# JONES & BEACH ENGINEERS INC.

**RE: Response Letter 3 – TAC Comments  
375 Banfield Road, Portsmouth, NH  
Tax Map 266, Lot 7  
JBE Project No. 19190.2**

We are in receipt of comments from Jillian Harris dated June 1, 2021. Review comments are listed below with our responses in bold.

DRAWING No. **T2**  
 SHEET 21 OF 24  
 JBE PROJECT NO. 19190.2

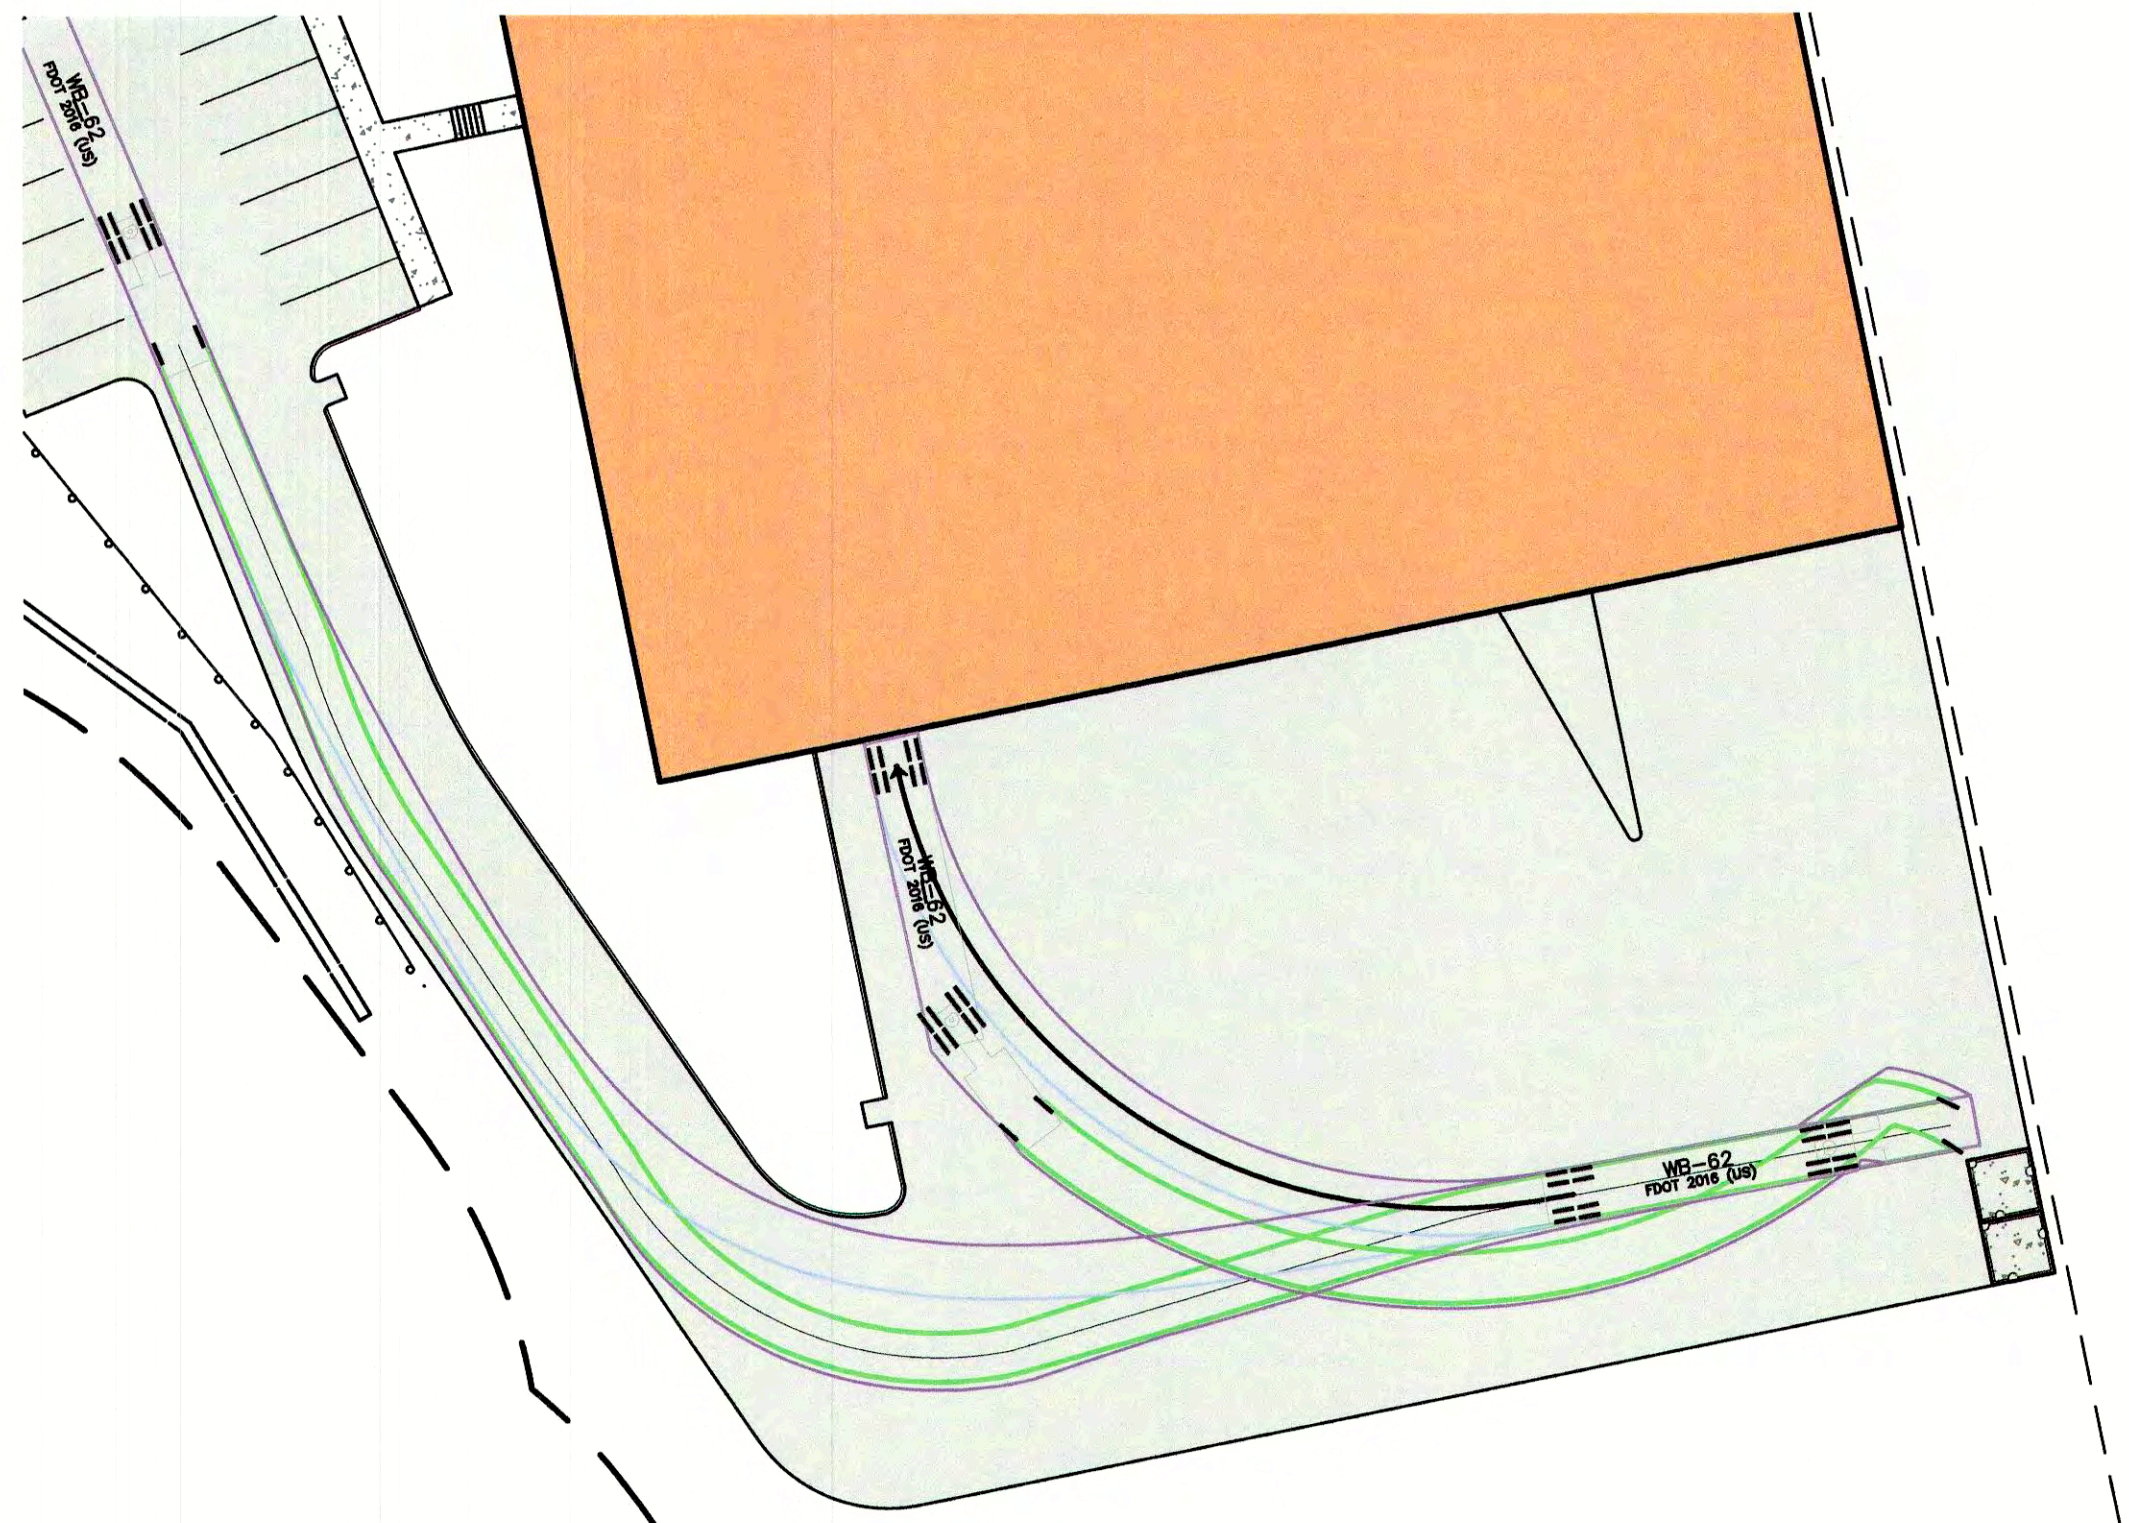
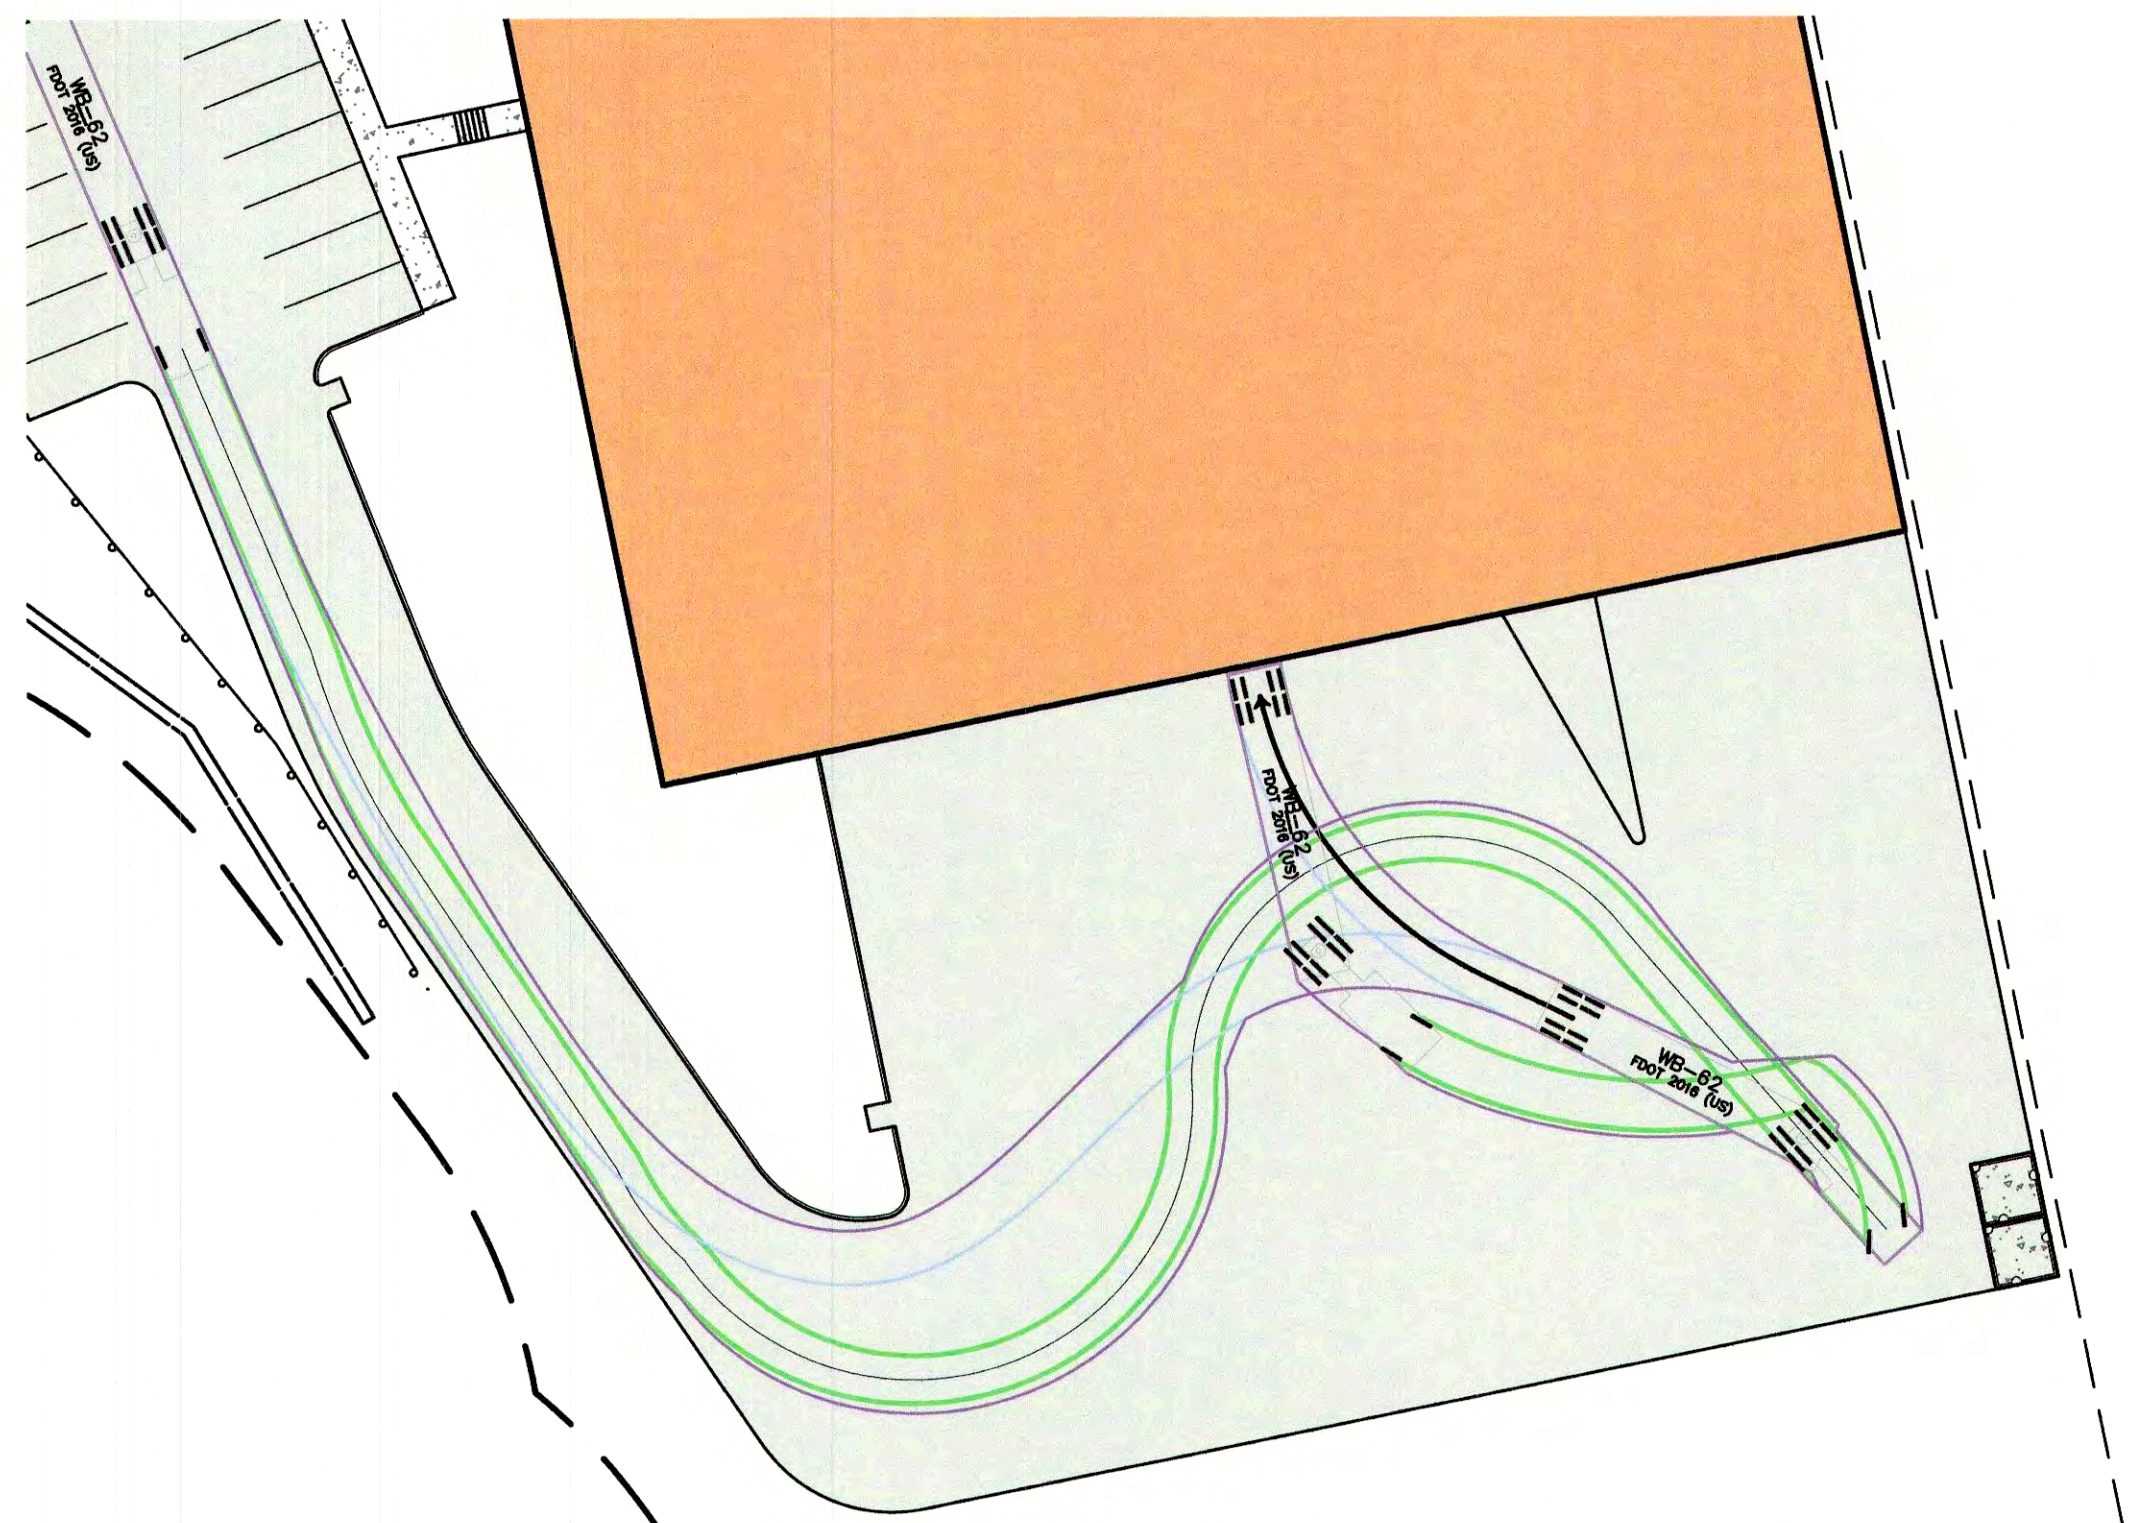
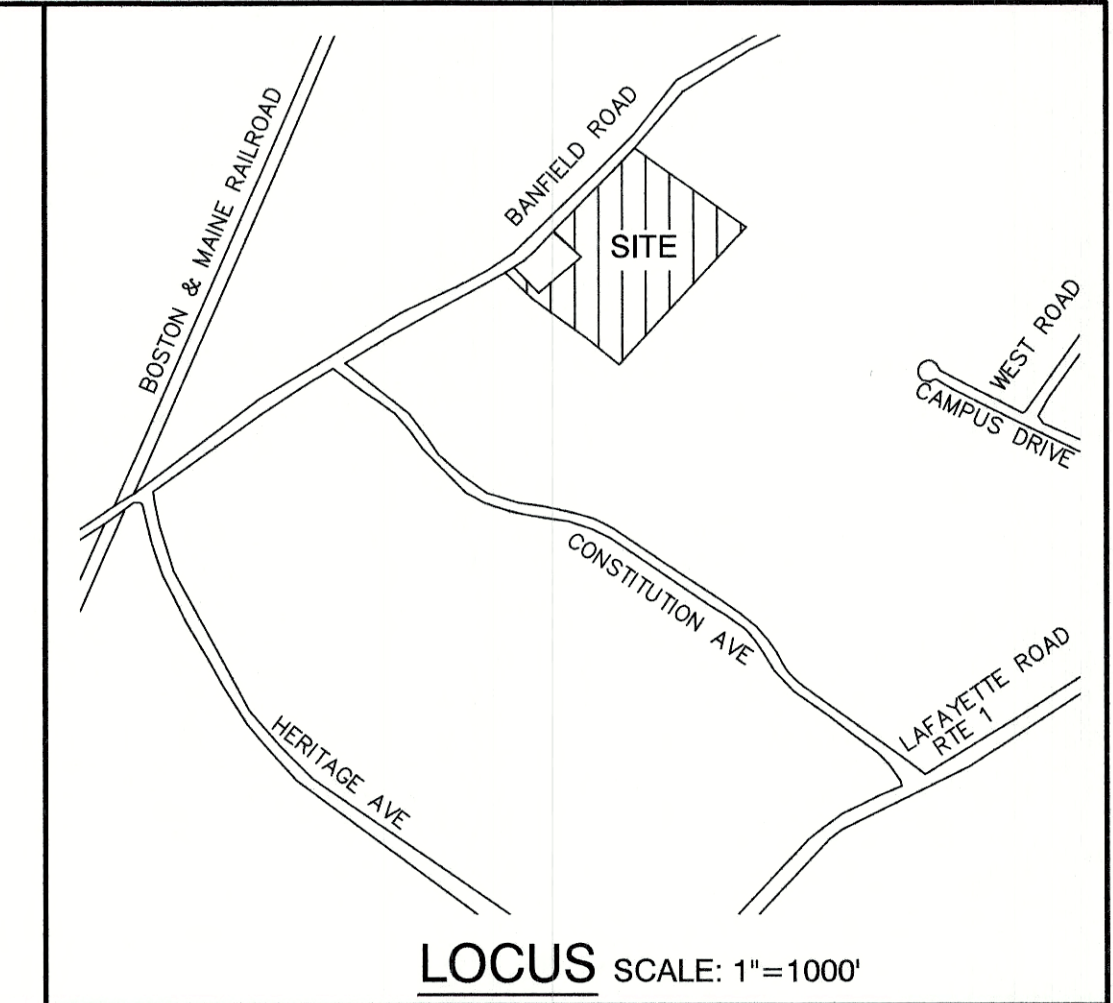
13. *Are there multiple loading docks and if so, the turning template should show how each dock would be accessed using the proposed pavement area.*

**RESPONSE: New truck turning templates have been added to Sheet T3 showing how different potential dock locations would be accessed.**
